**Report to Development Permit Panel**  
Planning and Development Department

**File:** DP 11-593925

**Re:** **Application by Cotter Architects for a Development Permit at  
14000 Riverport Way**

3. DP 11-593925 – SIX-STORY MIXED-USE DEVELOPMENT WITH 55 APARTMENTS  
OVER GROUND LEVEL COMMERCIAL AND AMENITY SPACE  
ARCHITECT: Cotter Architects  
PROPERTY LOCATION: 14000 Riverport Way

L-05

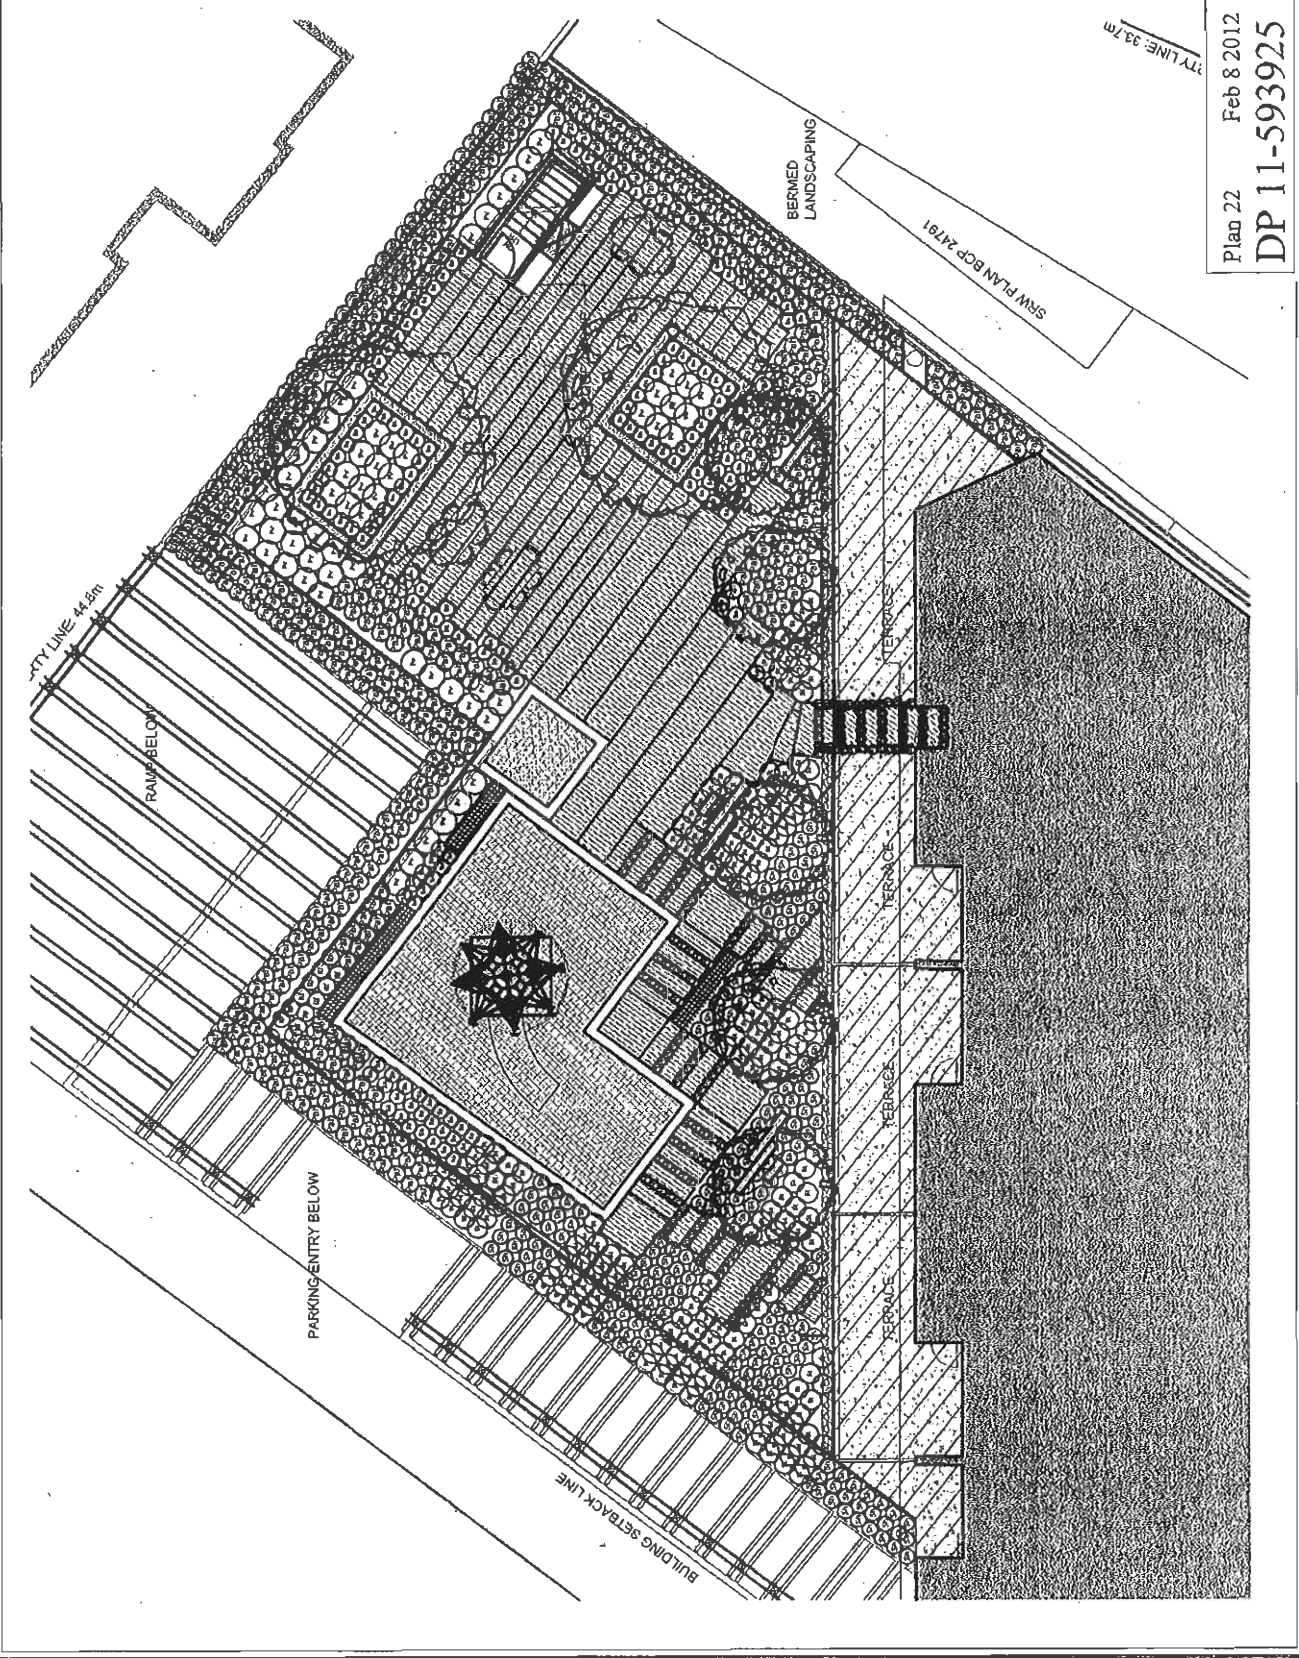
- berm transition at the back of parkade to the dyke is a bit clumsy as shown in section on L-05; context in the drawing on both sides would have been more helpful – *Improved with additional planting and architectural trellis with vine planting. Context included.*
